Responses to CEC Data Requests: Nos. A1 through A123

Amended Application for Certification for HYDROGEN ENERGY CALIFORNIA (08-AFC-8A) Kern County, California

**RESPONSES TO DATA REQUESTS A1 THROUGH A123
FROM CALIFORNIA ENERGY COMMISSION (CEC)**

**FIGURE A45-2
(REVISED FIGURE 5.2-7)**

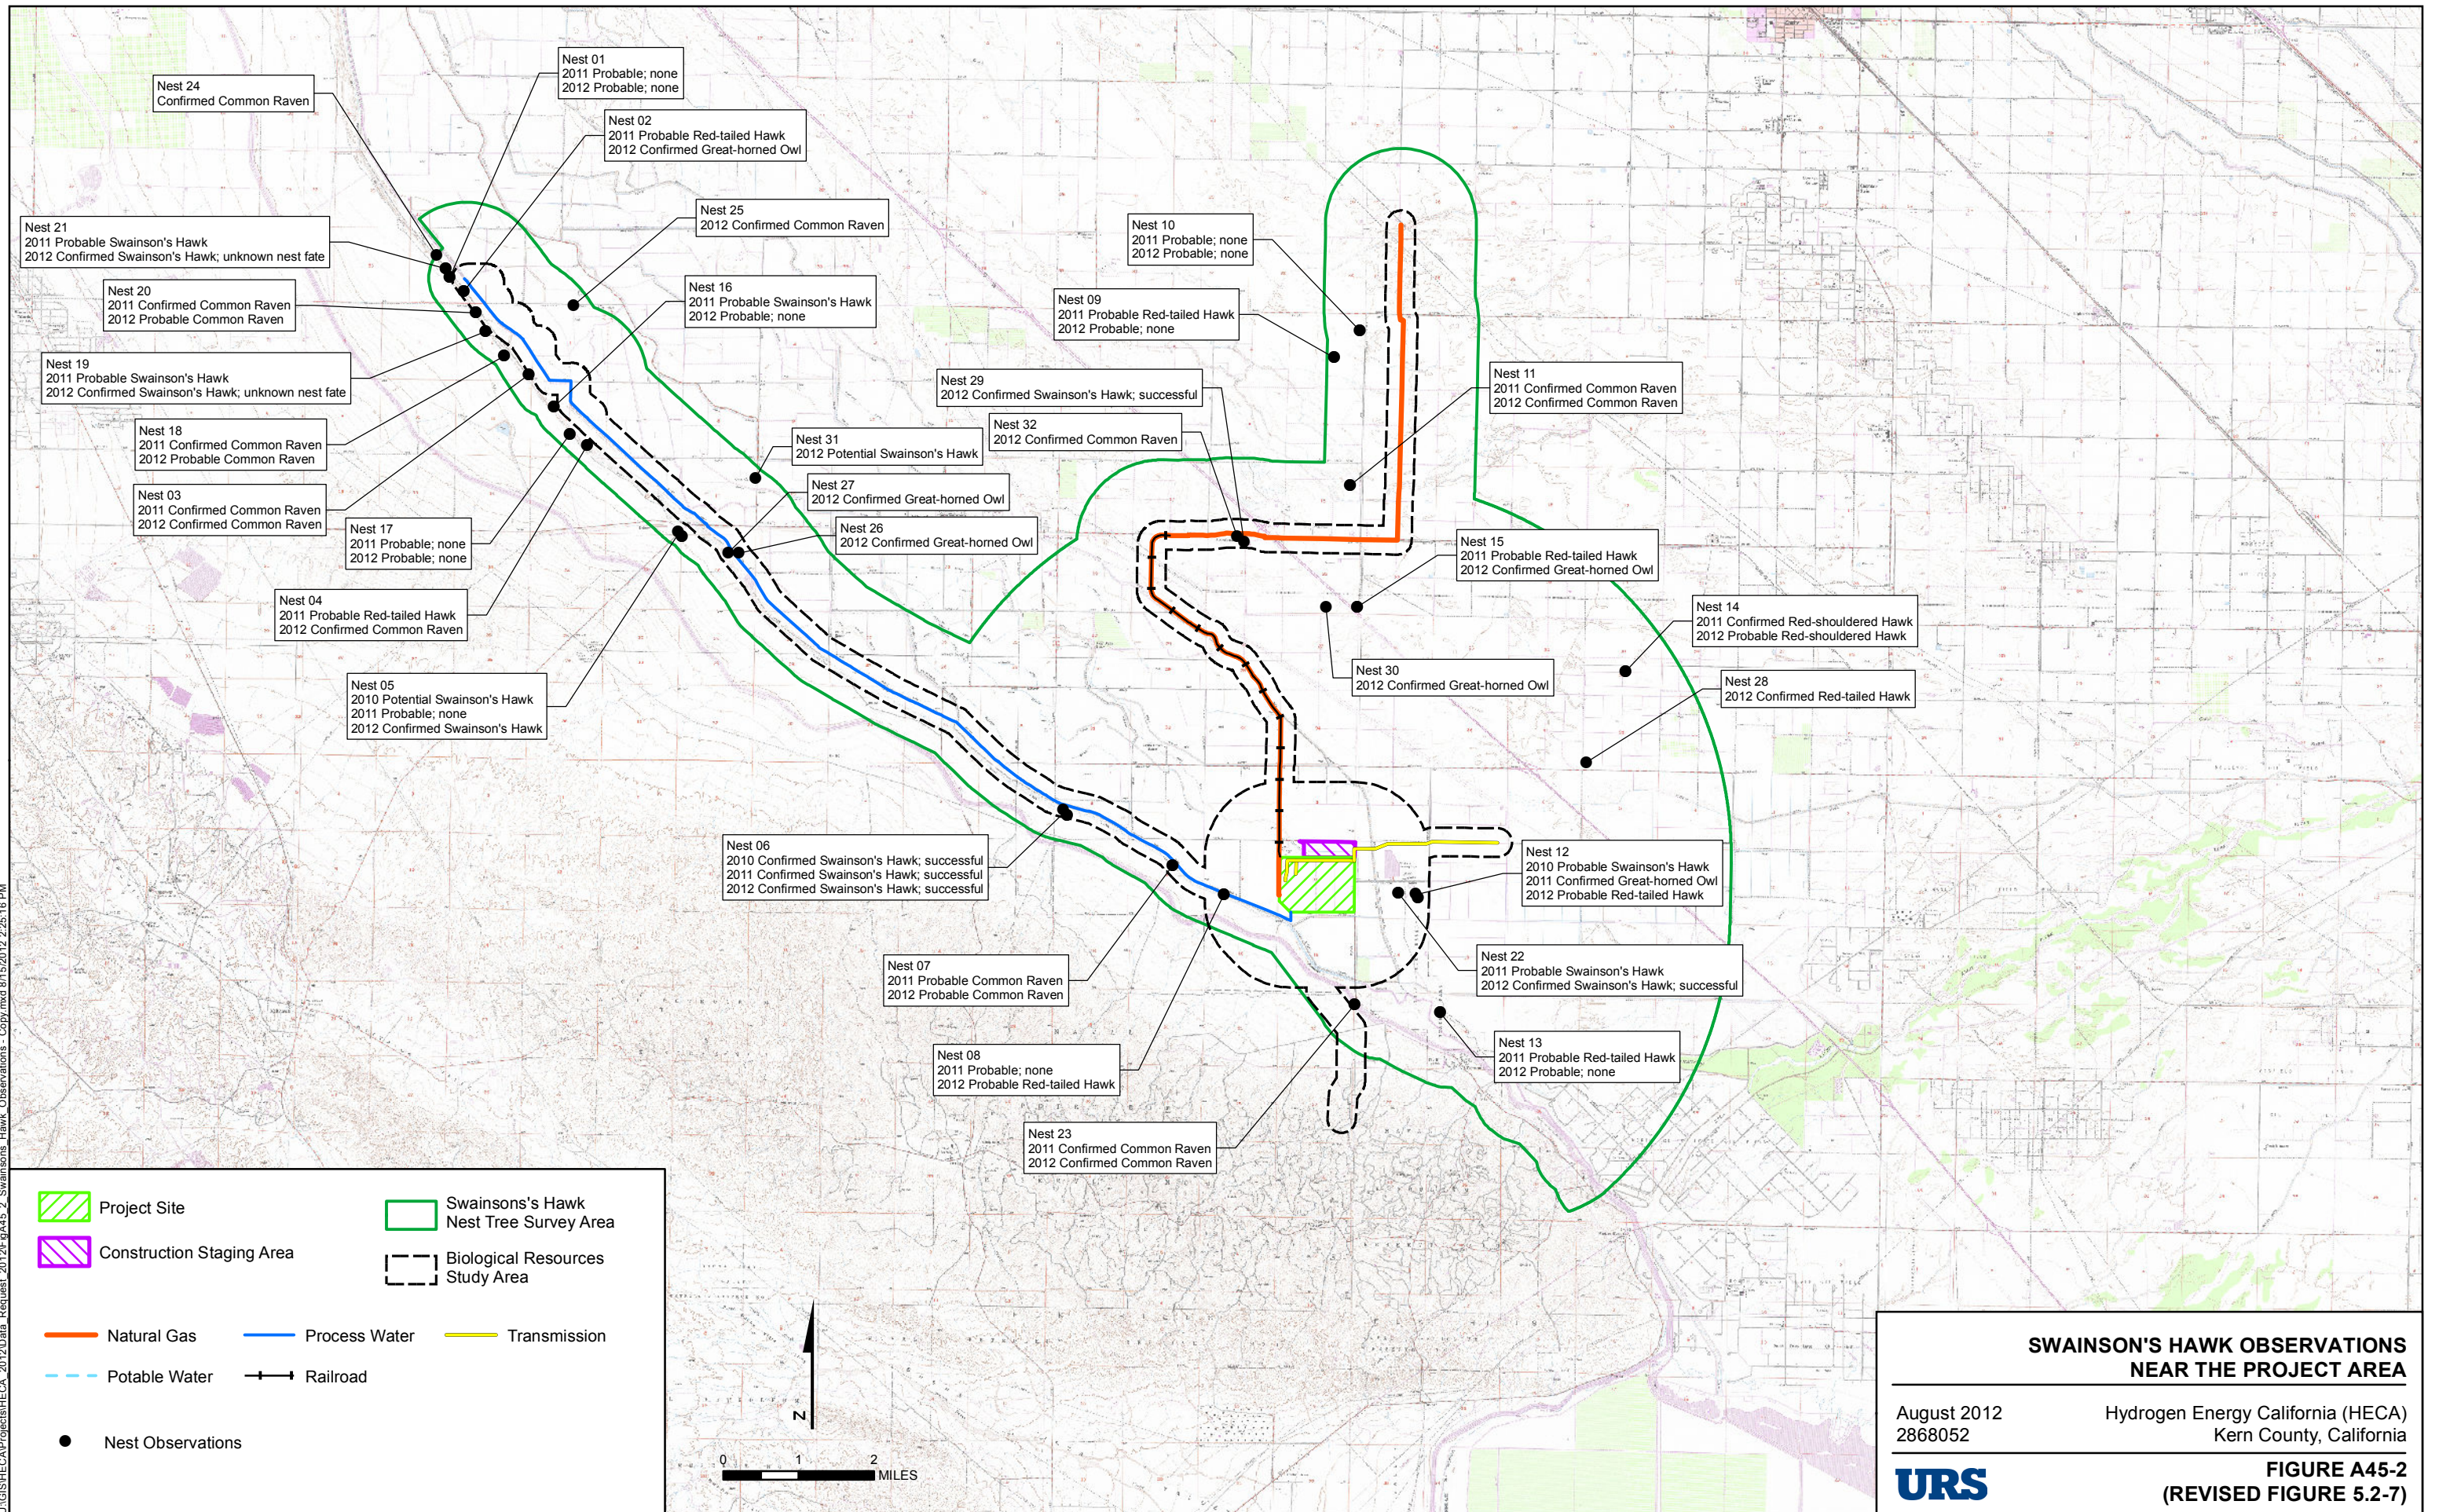
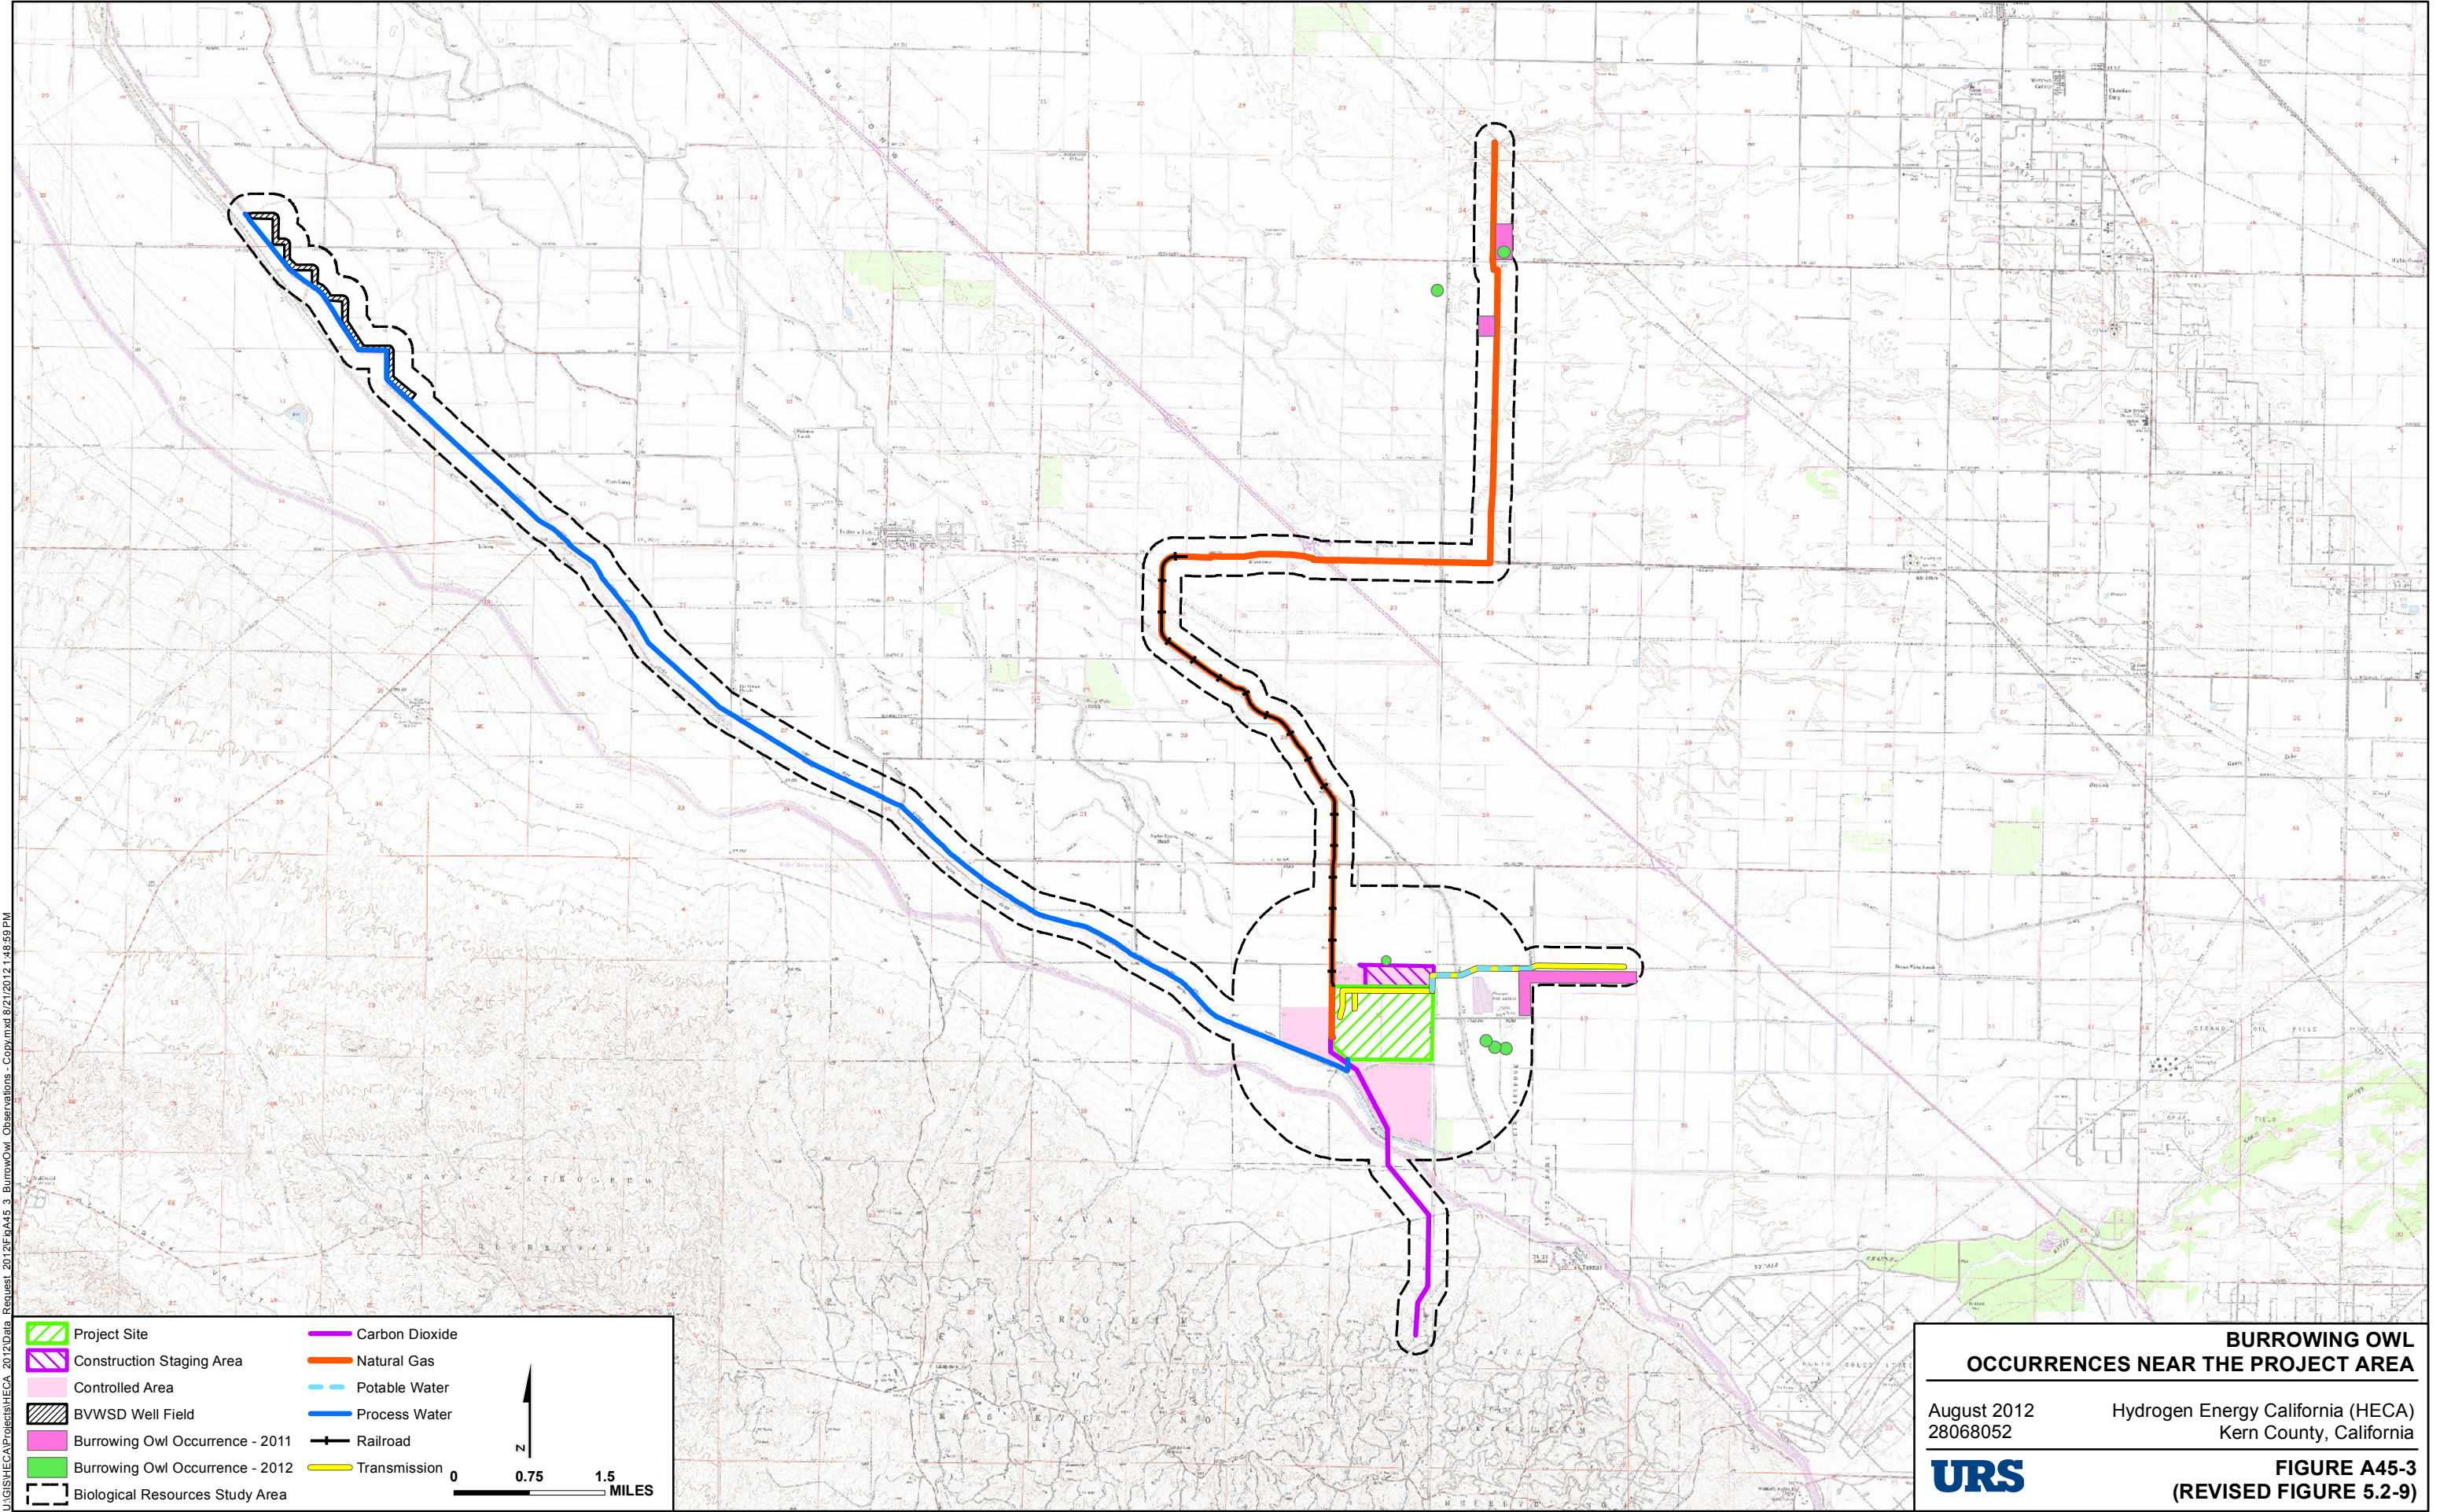
A45. Similar to Figure 5.2-6 in the Amended AFC, please provide three separate graphics showing all collected “URS-observation” GPS data, to date, for: 1) special-status plant species 2) burrowing owl and sign and 3) San Joaquin kit fox and sign. Also, please update Figure 5.2-6 with current blunt-nosed leopard lizard survey findings.

Seventeen active nests were identified in the Swainson's hawk survey area (Figure A45-2, Revised Figure 5.2-7). Six Swainson's hawk nests were identified; four were confirmed to have fledged at least one young, and were classified as "successful." Details for the Swainson's hawk nests during the five survey periods are detailed below. The other eleven nests belonged to common raven, great horned owl, red-tailed hawk or red-shouldered hawk.

FIGURE A53-1 (1)
(REVISED FIGURE 5.2-2)

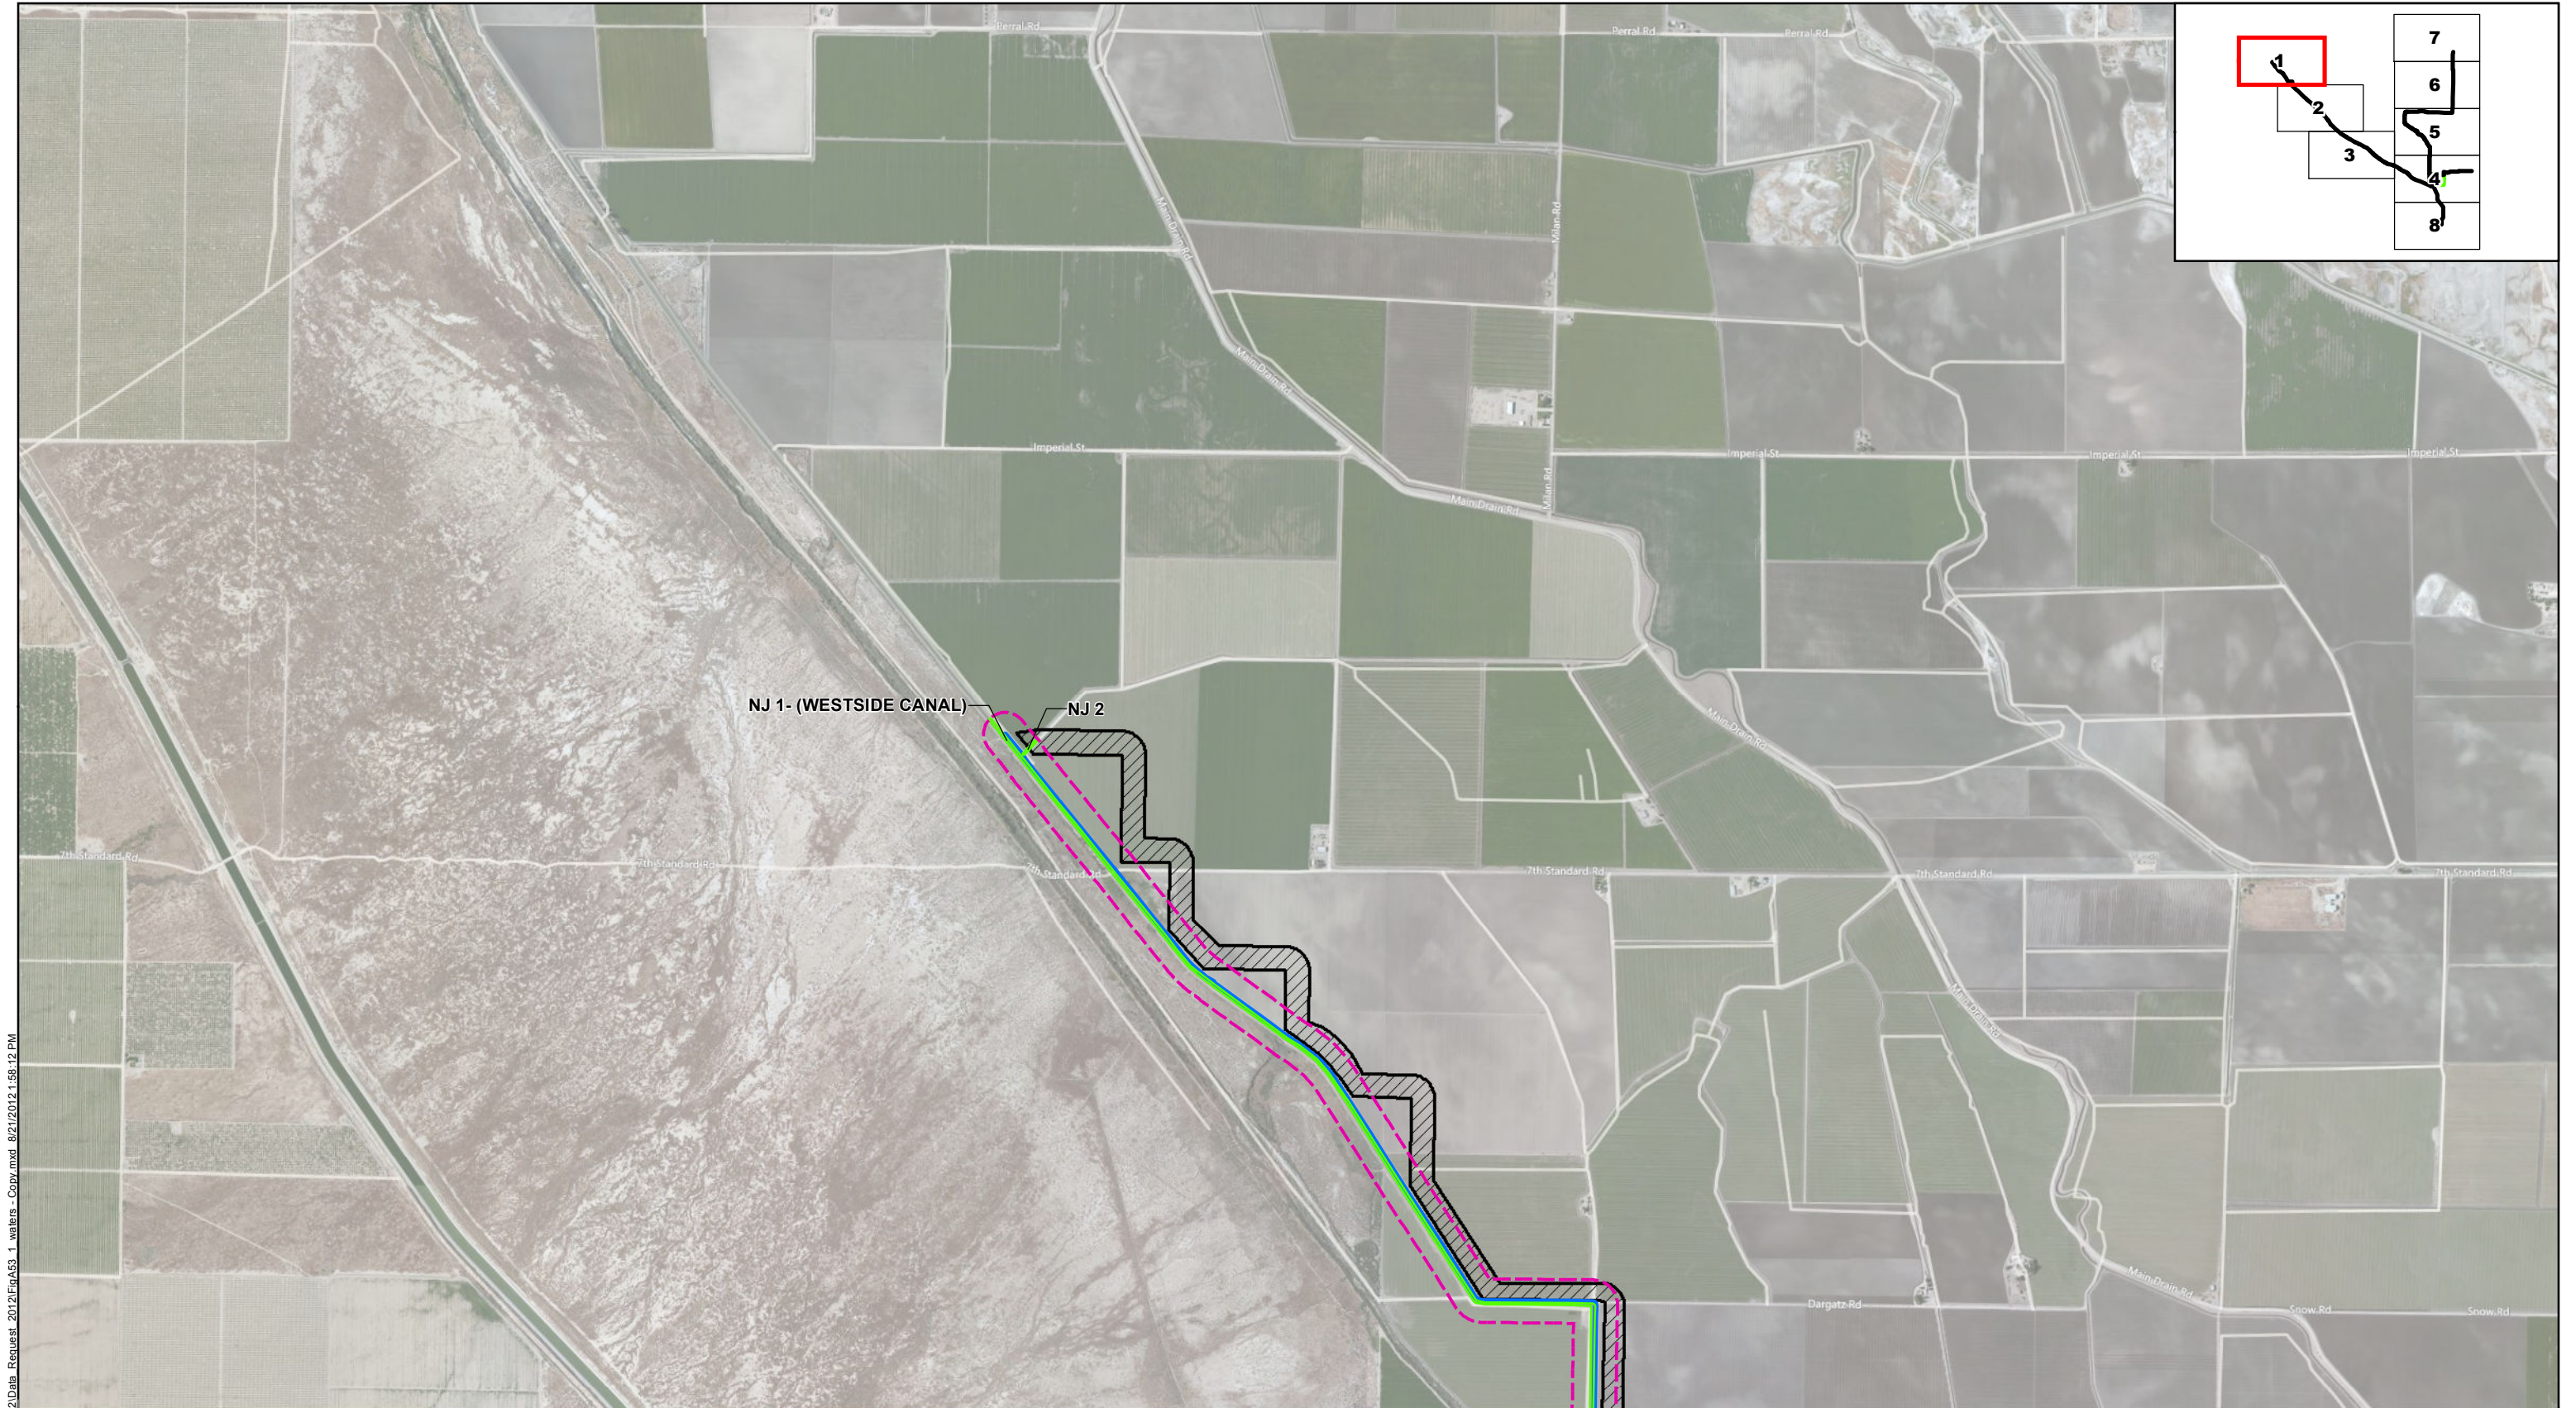
A53. Please identify which non-jurisdictional features represent the East Side Canal.

Figure A53-1 (Revised Figure 5.2-2) Waters of the U.S., identifies the location of the East Side Canal (see Sheets 4 and 5).
